From: Donna Gilmore <donnagilmore@gmail.com>
Sent: Monday, July 30, 2018 10:49 PM
To: Holtec-CISFEIS Resource
Cc: Donna Gilmore
Subject: [External_Sender] Docket NRC-2018-0052, Holtec HI-STORE Consolidated Interim Storage Facility Project Donna Gilmore Comments
Attachments: CommentsHoltecCIS-DocketNRC-2018-0052Gilmore.pdf

**RE: Docket NRC-2018-0052, Holtec HI-STORE
Consolidated Interim Storage Facility Project**

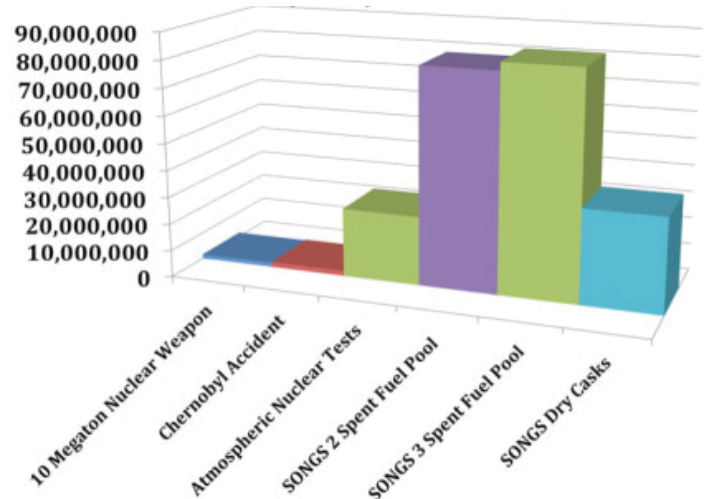
Holtec UMAX lids with large air vents. Round top has outlet air vent. Lower rectangular part of lid has inlet air vents near all corners. Radiation reading at San Onofre were 324 CPM (counts per minute) with no leaks in canister. Carbon-14 is one type of radioactivity released through the air vent. NRC only requires radiation monitoring once a quarter. No monitoring system exists to alert before leaks in canisters.
